Re: Permit Number 19-24934
MPAC Development
5 Hillside Court, Austin, Texas 78746
Lot 5, Hillside Vista Subdivision

Thank you for your review comments dated January 17 regarding the septic design submittal for the above referenced address. The following responses correspond in order to the comments contained in your letter:

REVISED SHEET 1.0 - OVERALL SITE PLAN

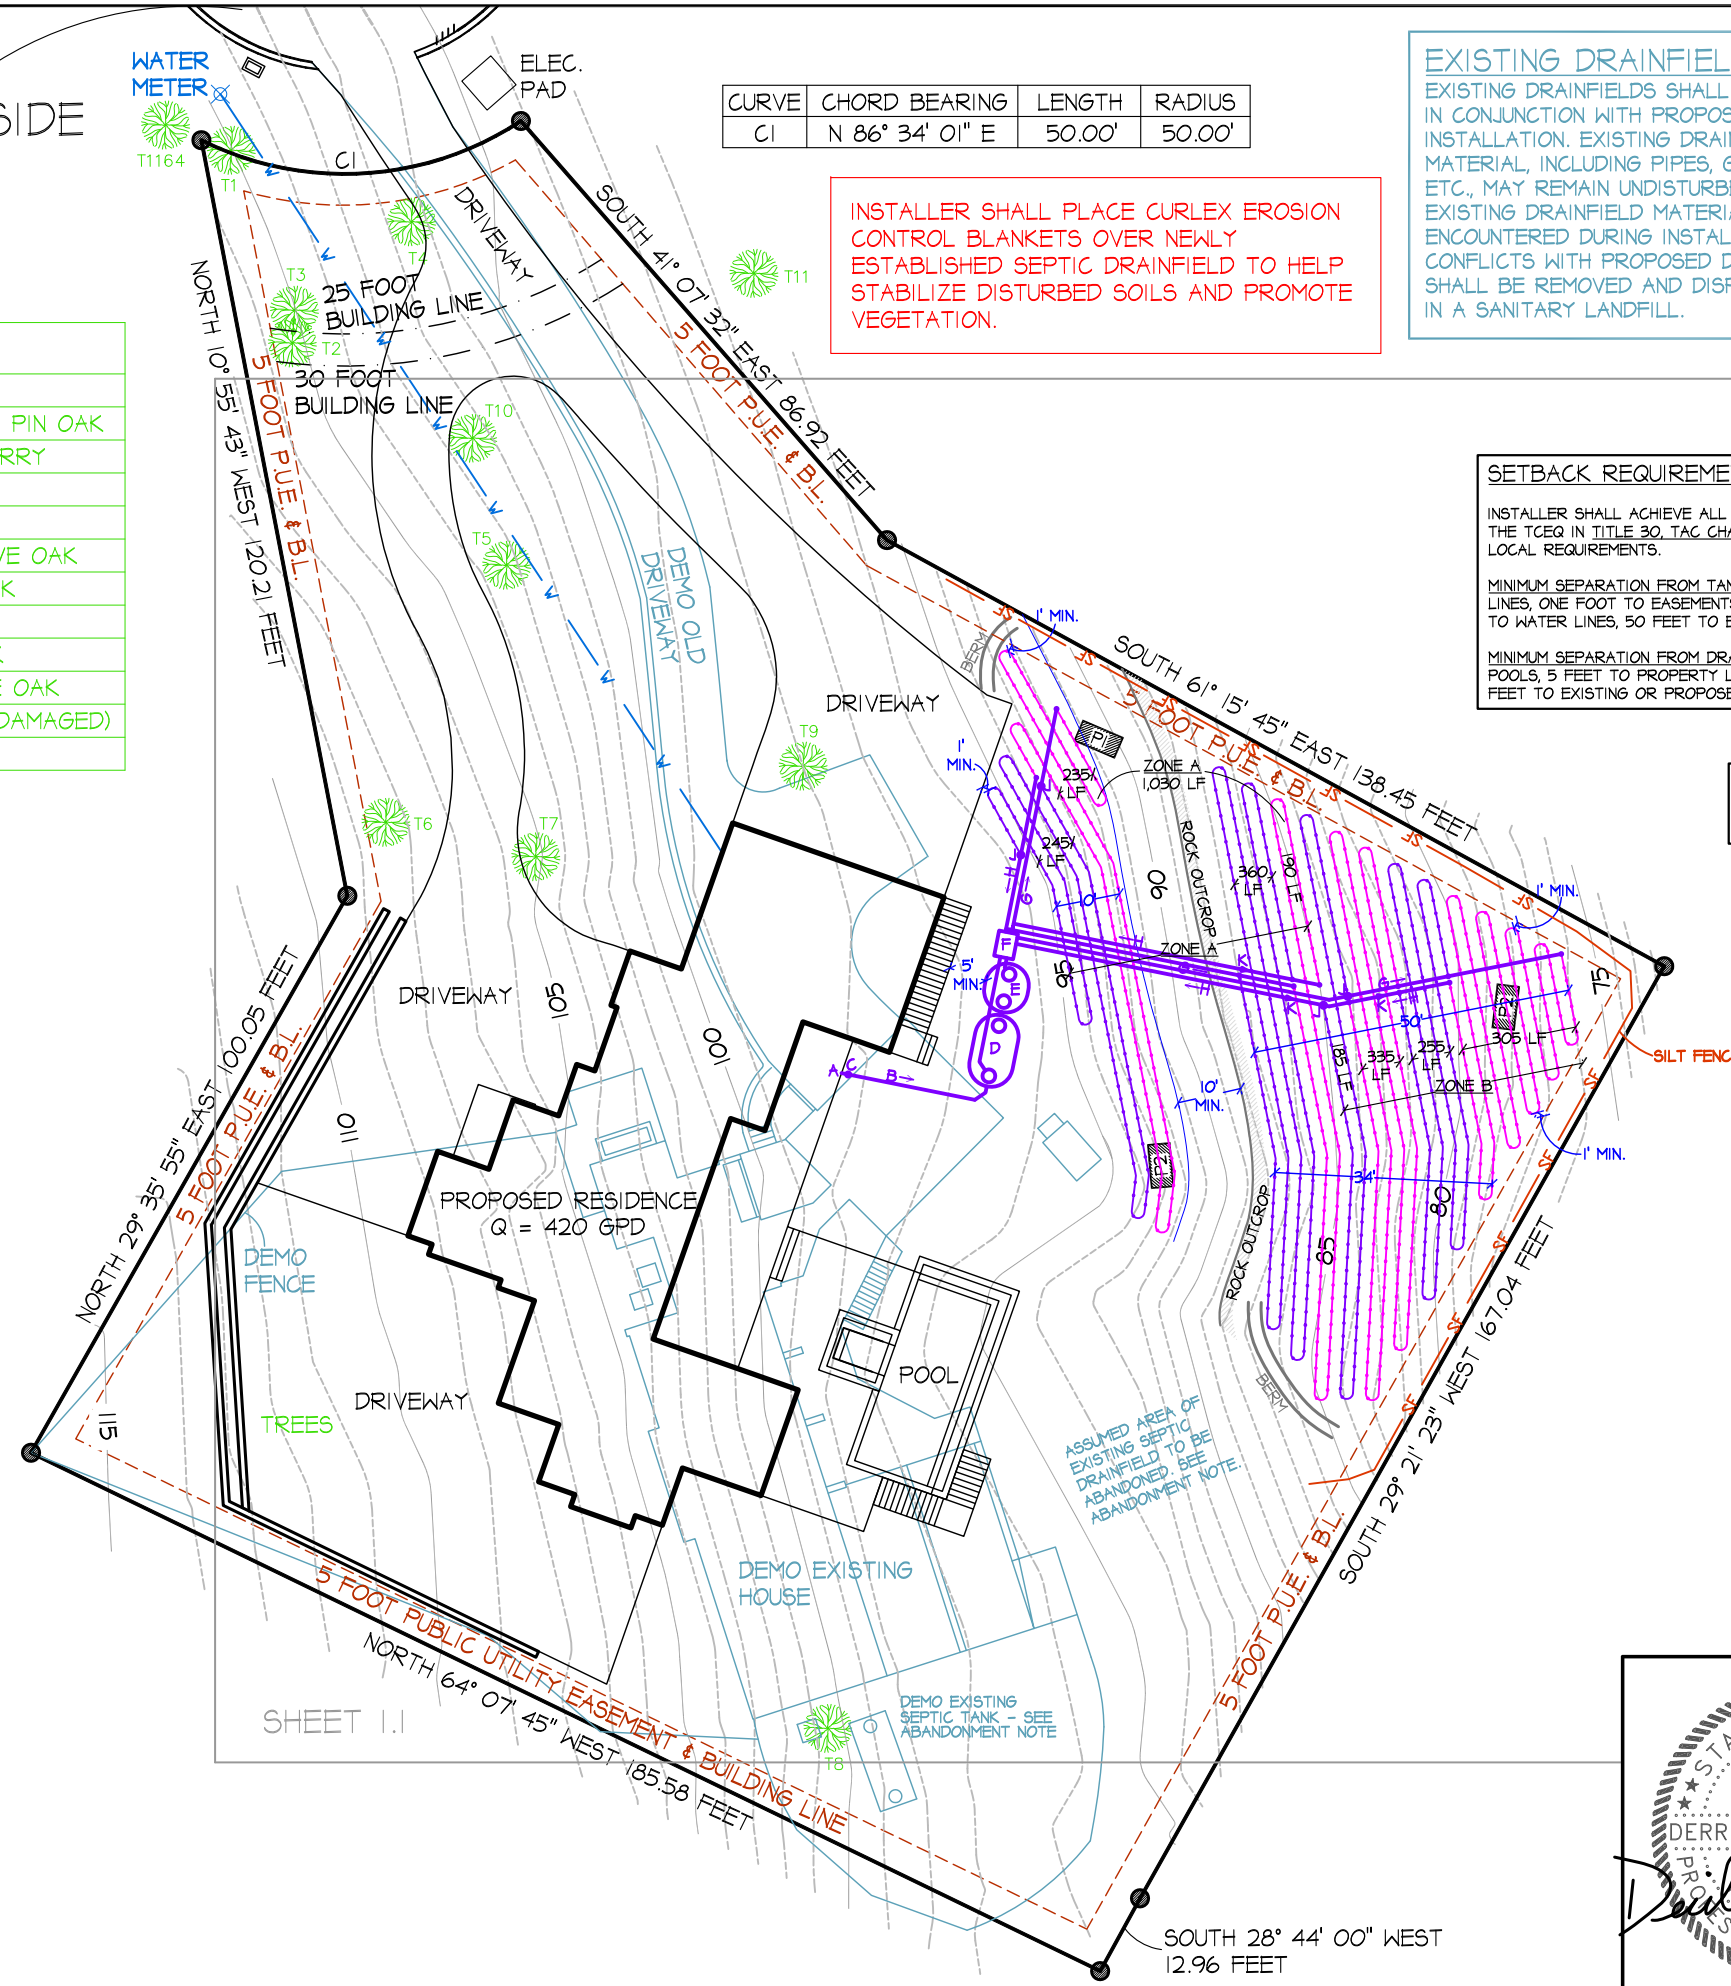
1. The soil profile holes will be re-opened and presented for review by your office at the first installation inspection.
2. Official documentation will be provided to your office demonstrating the appropriate pump-out of the existing tanks scheduled for abandonment. A pump-out manifest is typically offered from the licensed wastewater hauler.
3. I apologize for this discrepancy. The tank cross-section detail has been updated to show the correct dimensions and corresponding volumes for the float settings within the pump tank.
4. Thank you for pointing out this discrepancy. The detailed site plan has been updated to show the correct scale.
5. The updated site plan includes a note to place Curlex brand erosion control blankets over the installed system.
6. Please refer to the recorded aerobic affidavit included with this response.

EXISTING DRAINFIELD NOTE:
EXISTING DRAINFIELDS SHALL BE ABANDONED IN CONJUNCTION WITH PROPOSED DRAINFIELD INSTALLATION. EXISTING DRAINFIELD MATERIAL, INCLUDING PIPES, GRAVEL, SOIL, ETC., MAY REMAIN UNDISTURBED AND BURIED. EXISTING DRAINFIELD MATERIAL ENCOUNTERED DURING INSTALLATION, THAT CONFLICTS WITH PROPOSED DRAINFIELD, SHALL BE REMOVED AND DISPOSED OFF SITE IN A SANITARY LANDFILL.

EXISTING TANK(S) NOTE:
EXISTING SEPTIC TANK(S) SHALL BE ABANDONED. TANK(S) SHALL BE PUMPED CLEAN OF ALL EFFLUENT BY A LICENSED WASTEWATER CARRIER HOLDING A CURRENT LICENSE WITH THE EXECUTIVE DIRECTOR. PROOF OF THIS PUMP-OUT SERVICE SHALL BE AVAILABLE FOR REVIEW BY INSPECTORS. LID, WALLS AND BASE SHALL BE CRUSHED AND BURIED IN PLACE. REMAINING VOID SPACE SHALL BE BACKFILLED WITH CLEAN NON-EXPANSIVE SOIL.
